Intel® Desktop Board DH55PJ Specification Update

Order Number: E96959-004US

Specification Changes

Figure 1. Connection Diagram for Front Panel USB Headers

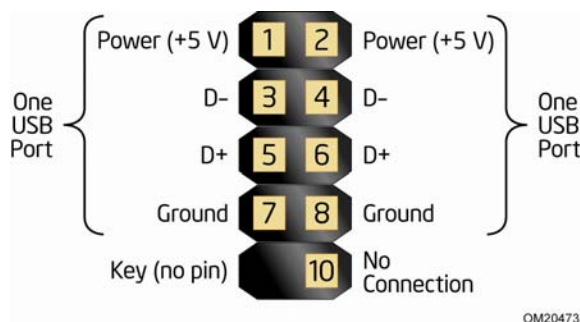
1. Updated Section 2.2.2.1 Signal Table for the Connectors and Headers, Section 2.2.2.2 Add-in Card Connectors, and Section 2.2.2.6 Front Panel USB Headers of the *Intel Desktop Board DH55PJ Technical Product Specification* as shown below.

Figure 12 is a connection diagram for the front panel USB headers.

- The +5 V DC power on the USB headers is fused.
- Use only a front panel USB connector that conforms to the USB 2.0 specification for high-speed USB devices.
- USB Header 2 (FP USB 2) has Pin 10 routed to the HDD LED to support specific USB SSD devices. Connecting any device to this header, that has any connection to Pin 10, may cause the HDD LED to behave erratically or stay on continuously.

Figure 2. Connection Diagram for Front Panel USB Header 2

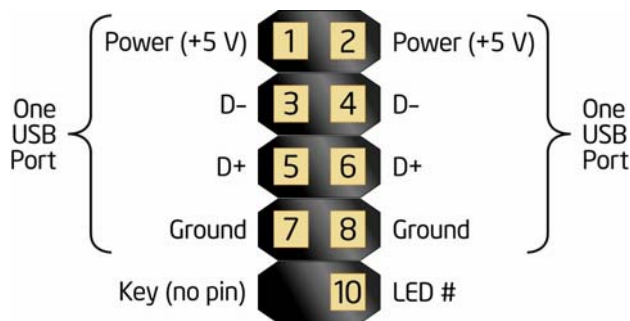
Table 1. Front Panel USB Header 2

Pin	Signal Name	Pin	Signal Name
1	+5 VDC	2	+5 VDC
3	D–	4	D–
5	D+	6	D+
7	Ground	8	Ground
9	KEY (no pin)	10	LED#
